PZ&B Staff Combination Memorandum: Landmarks Preservation Commission and Town Council

SUBJECT: COA-24-0002 (ZON-24-0009) 195 VIA DEL MAR (COMBO)

MEETING: AUGUST 21, 2024, LPC
SEPTEMBER 11, 2024, TC

"Preferred" Design

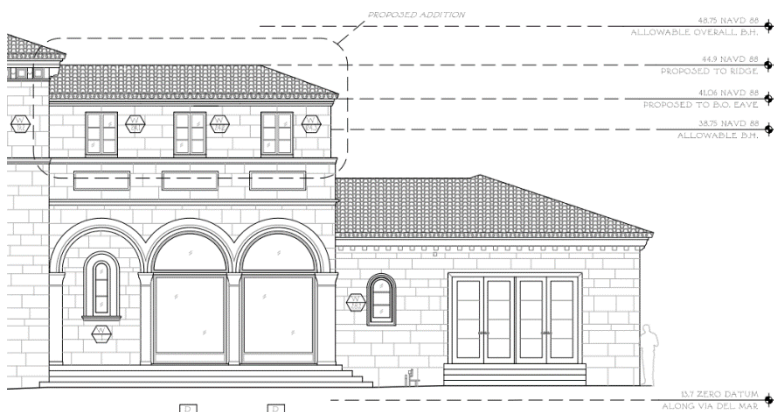
The applicant submitted revised plans that outlined a "preferred" and an "alternate" addition design. The preferred option matches the design presented at the June 21, 2024, and July 17, 2024, LPC meetings.

The "alternate" design lowered the building height and overall height of the addition by approximately 1'-3". The "alternate" design presents an addition that is adequately subordinate to the abutting mass of the residence.

The previous "alternate" design, presented at the July 17, 2024' LPC meeting, also lowered the building height and overall height of the addition by approximately 1'-3". The roof design was modified to have only one hip end (instead of two). However, the blank niches were eliminated on the north façade. Based on Commissioner comments, this feature was reintroduced.

“Preferred” Design

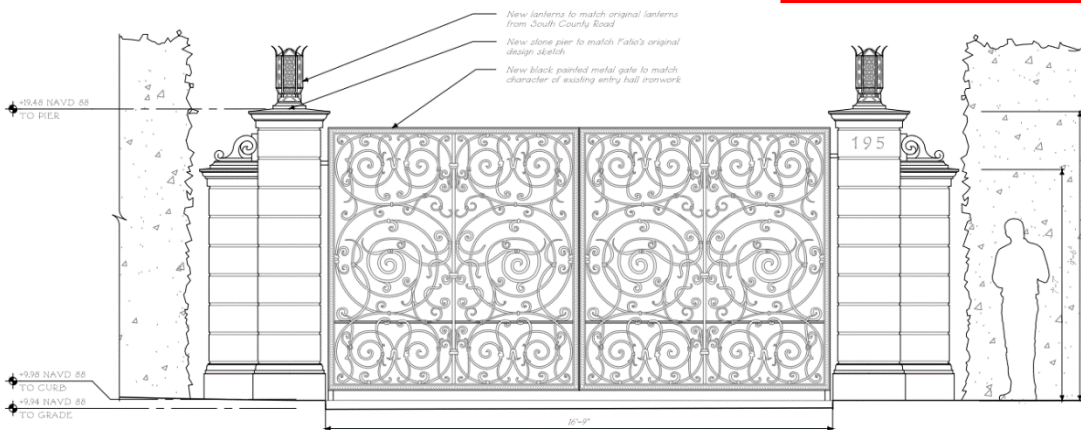
The applicant submitted revised plans that outlined a “preferred” and an “alternate” design. Both options feature ornate ironwork inspired by the existing front entrance gate.

Based on Commissioner comments, the applicant pursued gate post and gate proportions inspired by the original plans. As a result, a variance is required to achieve a height of 9'-6" in lieu of the 8'-0" maximum permitted for gate posts and gates in a front yard.

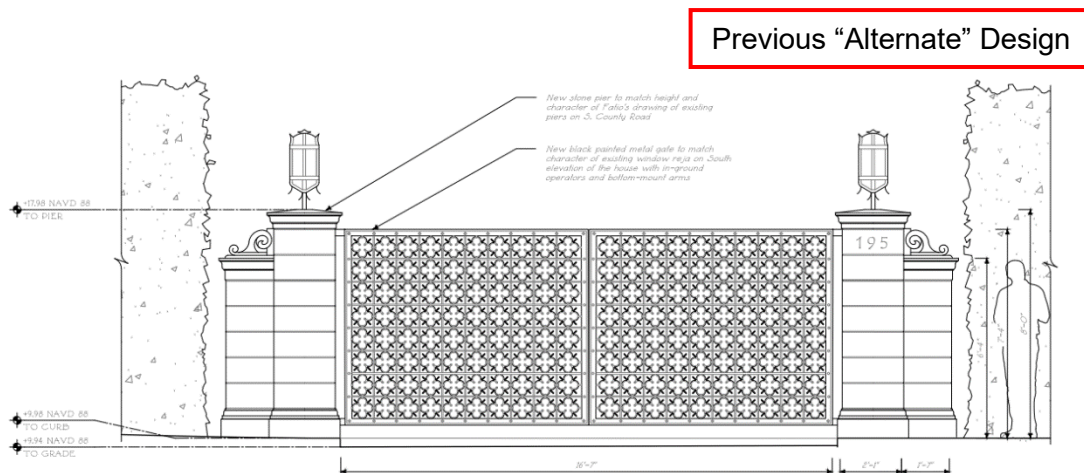
The "alternate" option matches the design of the "preferred" option at a lower height that is zoning code compliant.

ORIGINAL FATIO DRAWING OF VIA DEL MAR FRONT GATE

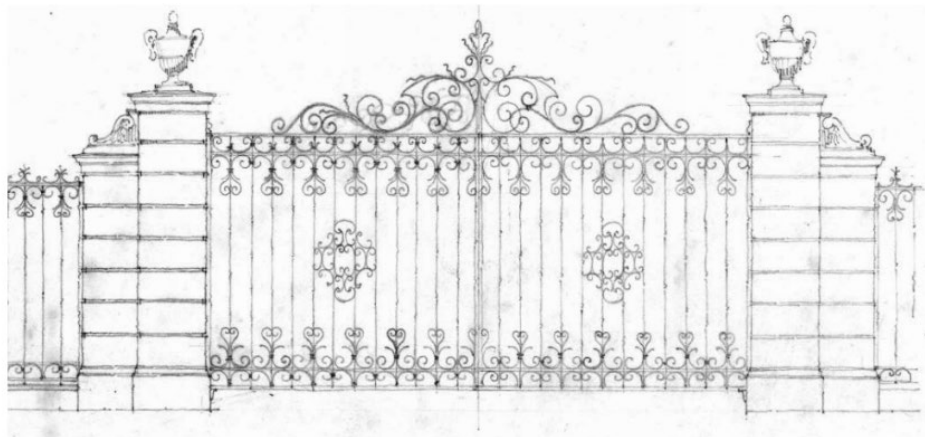
From a historic preservation perspective, the “preferred” option is desirable since it seeks to reconstitute original gate post and gate proportions. Replicating the original gate design (as shown below) would also be highly desirable, as it incorporates a feature proposed by Fatio that was never actually constructed.
